## Central Zoo Authority

F. No. 19-123/93-CZA(267)(Vol. I)(NS)/6944

**Sub:- Designs for the proposed construction of enclosures at Malsi Deer Park, Dehradun, Uttarakhand - Reg.**

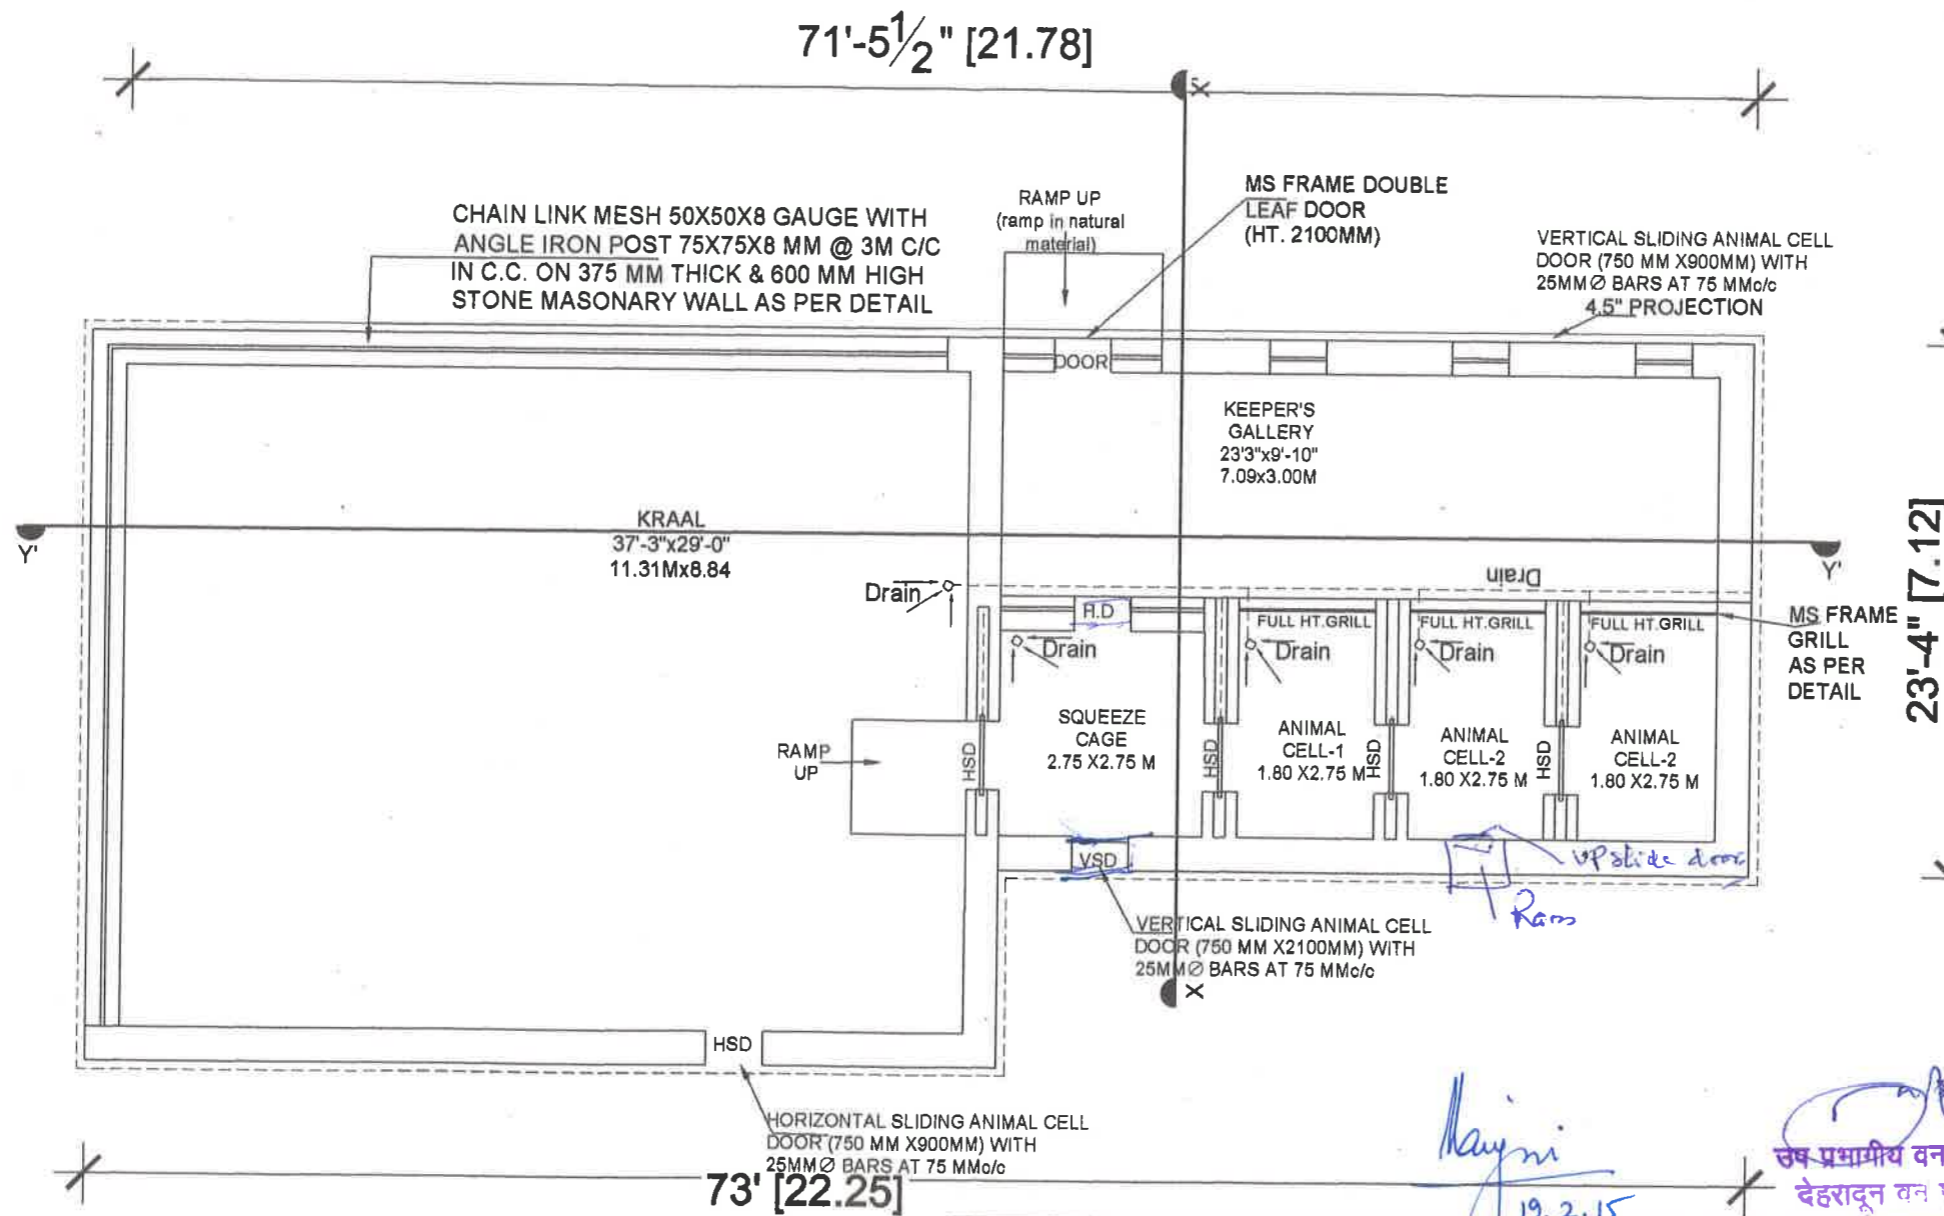
- There should be no opening towards the paddock from the squeeze cage and animal should go through one of the feeding cells.
- Appropriate drop gate may be provided for the purpose.

*Handwritten notes:*  
 1) May be approved subject  
 2) The opening should be no  
 cage padlock as animal should be  
 through as one should be squeeze  
 - Appropriate for the purpose  
 for the purpose of the project  
 19/2
